14 November 2022

Liam Hearne, Senior Project Manager
TSA on behalf of Health Infrastructure
Level 24, Allendale Square
77 St Georges Terrace, Perth, WA 6000

Interim Site Audit Advice No 01, BE167, Royal Prince Alfred Hospital, Remediation Action Plan review

Figure 1 Lot and DP plan from <https://www.planningportal.nsw.gov.au/spatialviewer/>

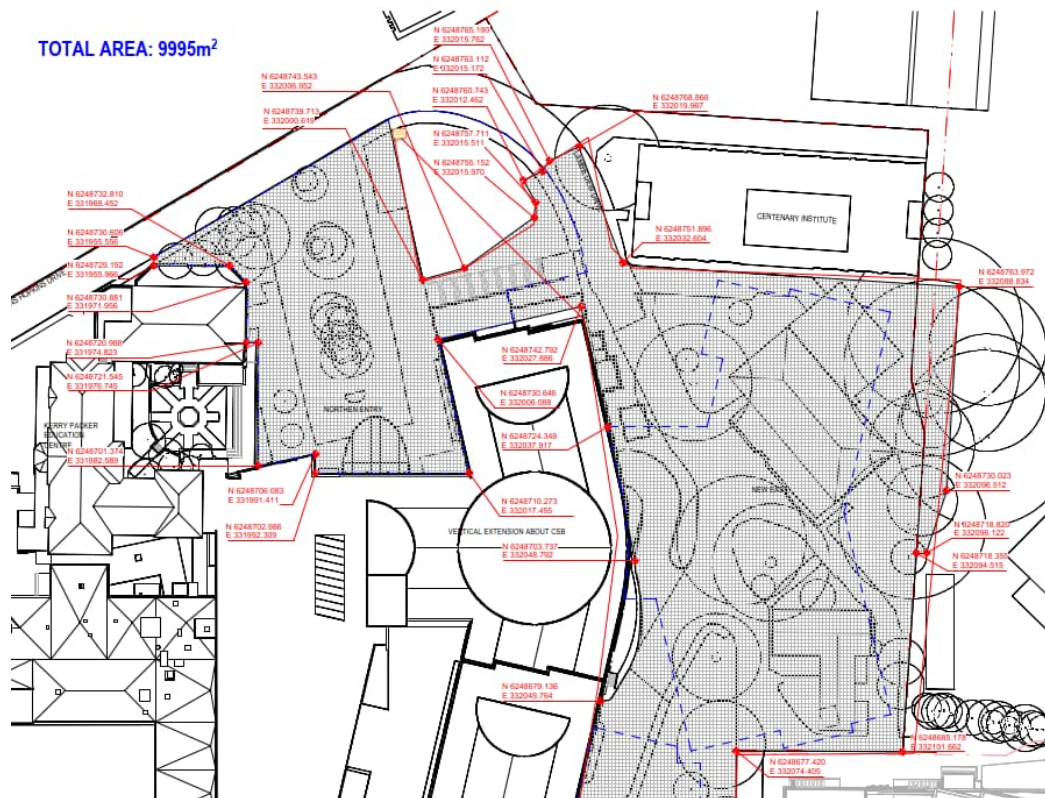
- Based on figures in the Cardno (2022j) RAP and the Cardno (2022g) DSI, the area of disturbance (i.e., the area that will potentially be subject to remediation) includes a portion of adjacent Sydney University land, identified as part Lot 1001 DP 1159799 and part Lot 1 DP 1171804. See Figure 1 and Figure 2 below.

- The total area described in Drawing 11/02/22_ IA0251300- SK-SK-2001 Extent of Works Diagram included in the Cardno (2022i) DSI indicated the total area to be 9,995m². The site identification table in the DSI indicated the total area to be 9,320m² (1,205+155+6,748+1,212) when the areas are added (see Table 2 below). The Auditor considers that these discrepancies should be addressed by providing a survey plan of final the remediated area in the validation report.

Figure 3 Proposed Schematic of Capping (Cardno, 2022j)

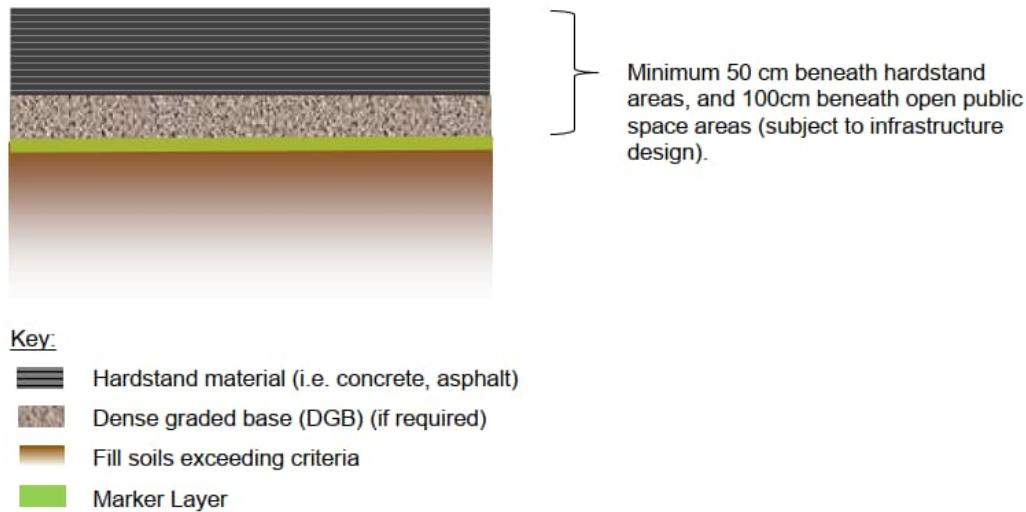
The Auditor does however note that there was no rationale was provided for the proposed capping thickness and is of the opinion that final capping thickness should be dependant on the earthworks plan. Regardless, the capping thickness should be a minimum of 100mm plus landscaping.

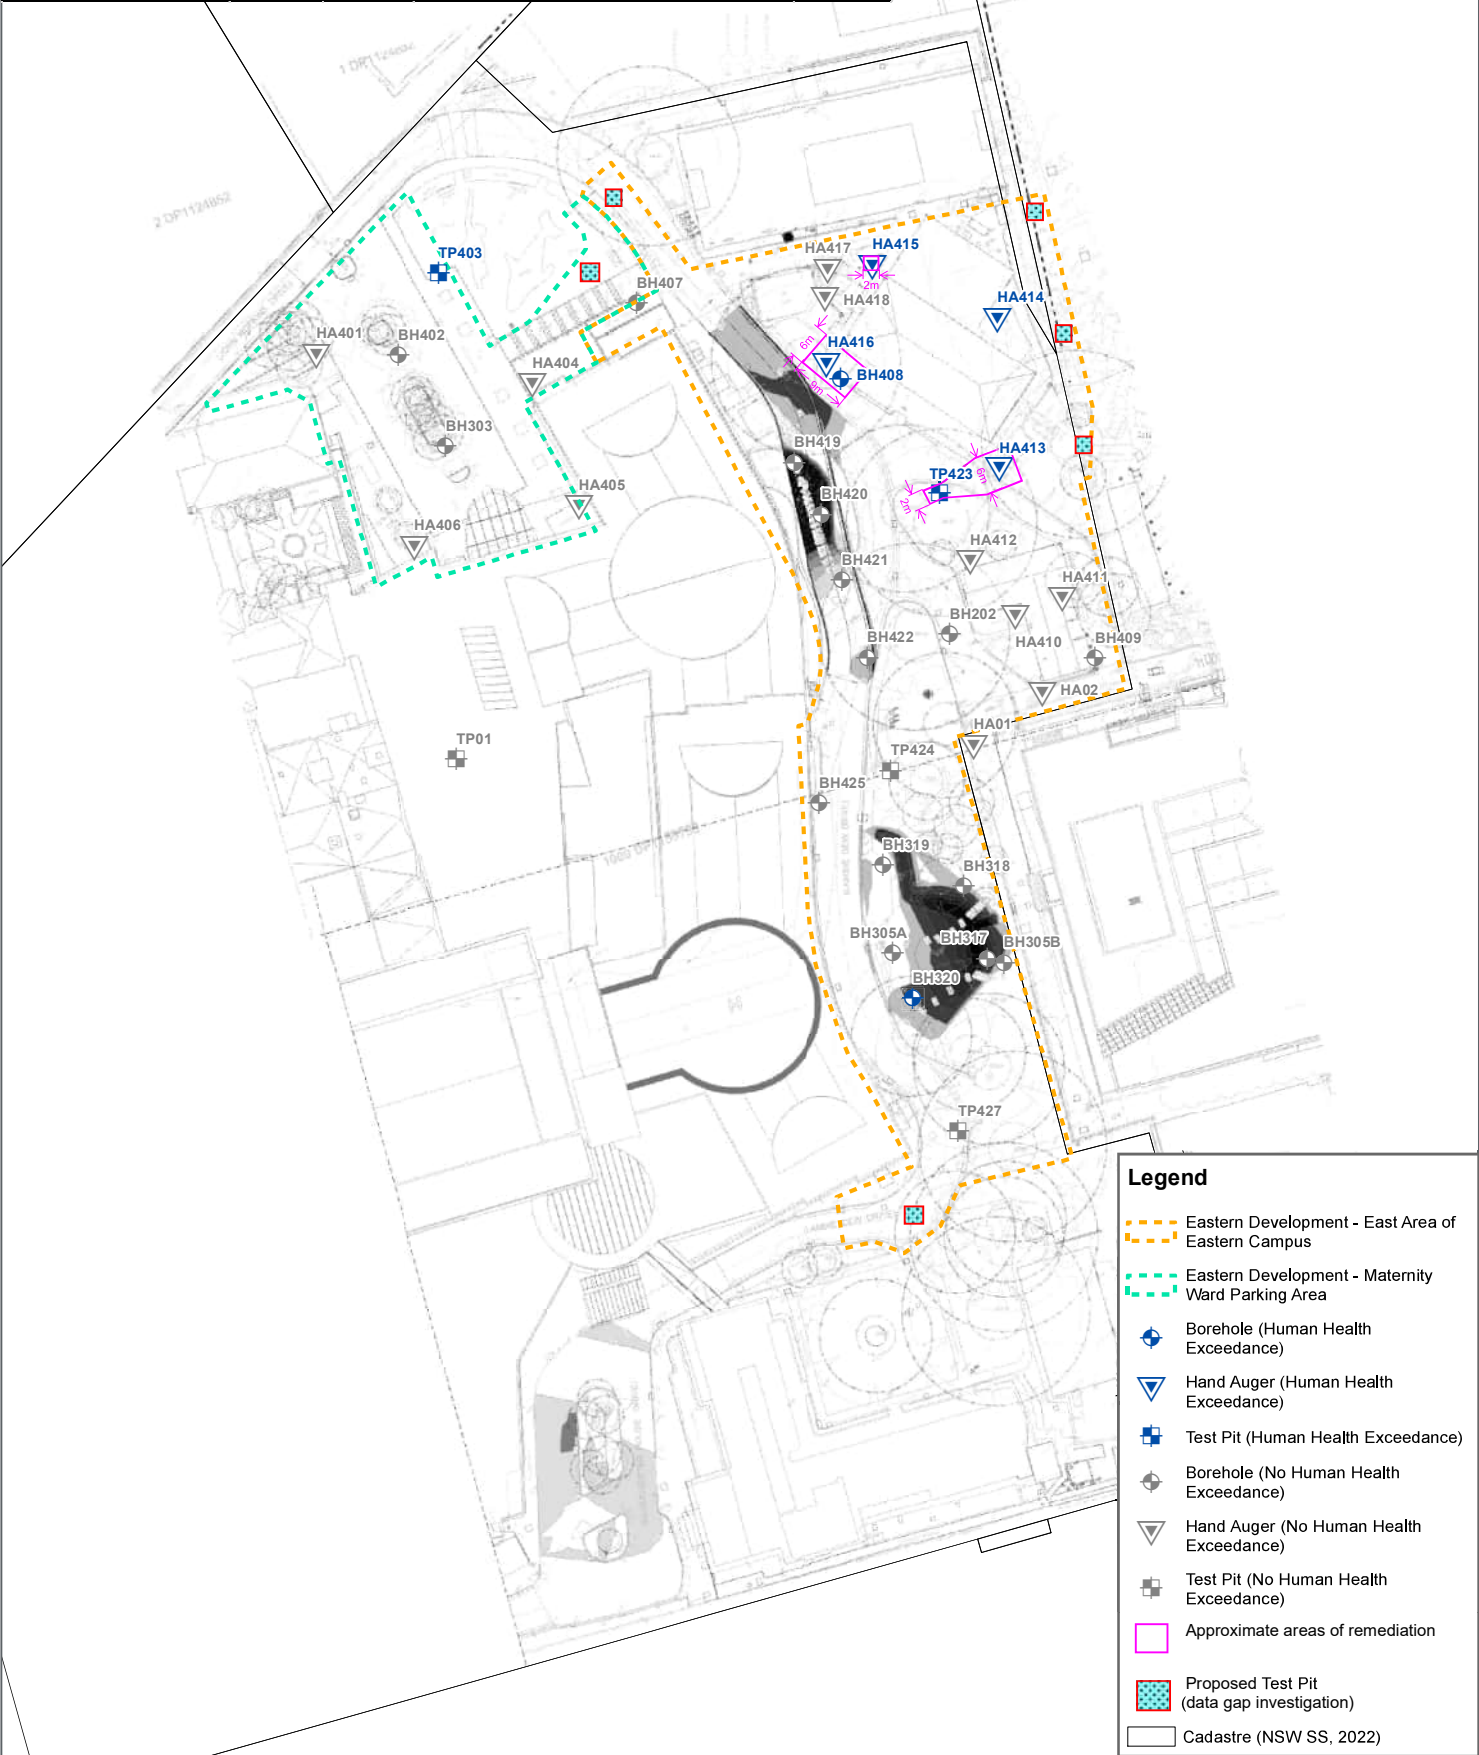
63	Figure 4	Please confirm the discrepancy between the sample location labels and those described in the tables. It appears that some are labelled as TP in the figure and BH in the tables. If this is the case, please provide a table showing which TPs and the same BH.	It is noted that the borehole sample was collected as BH01, but given that the borehole was done in conjunction with the geotechnical report, the geotech team labelled the borehole as TP301. As such for consistency across figures from geotech report and environmental report, the label TP301 was adopted. This is outlined under section 3.3, we have presented BH1 and in brackets have TP301 thus indicating they are the same borehole.	Noted. The Auditor will provide further discussing in the ISAA.
